Glacier Gulch Water Group's comments on Thompson Creek Metals' 2013 Davidson Project Care and Maintenance Plan and Closure Report Update

GGWG 1 June 2013

Figure 1: Time series of dissolved arsenic values at A1 (1066m portal) and A5 (below dump) between 2006 and 2011 showing an increase in A5 arsenic values (TCM file 11.13.10 Davidson WQ graphs).

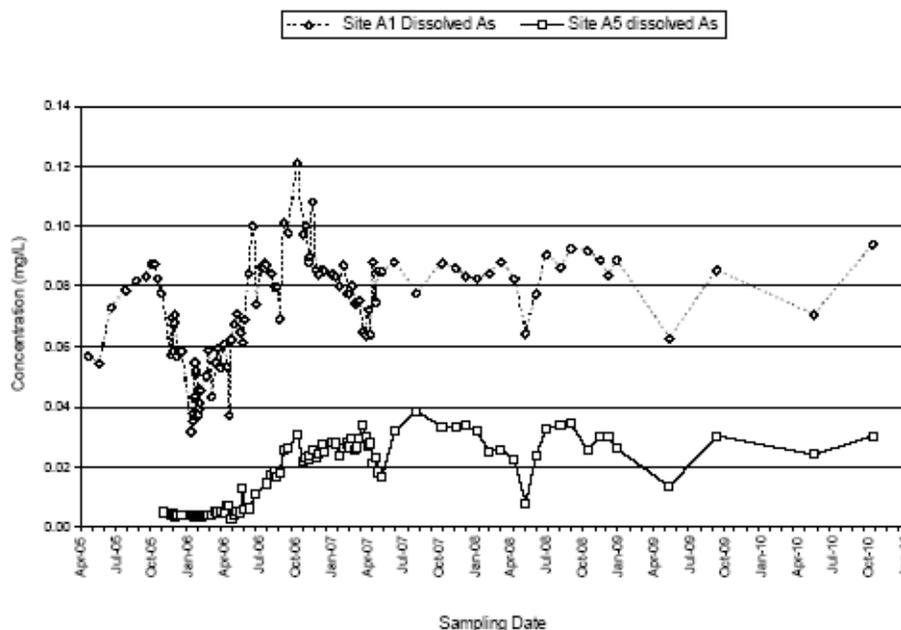
- Morin's review of the decline in the arsenic content of A1 water between A1 and A5 revealed that the arsenic is being trapped in the dump. He listed conditions which could release the trapped arsenic. These included a heavy rainfall, anaerobic conditions, mechanical movement.
- The time series trend in A5 arsenic level at a scale that displays individual water monitoring samples indicate that the arsenic levels have increased with time (figure 1). A limited arsenic carrying capacity for the dump is indicated.

21) How will TCM accommodate these new constraints in its dump closure plan?
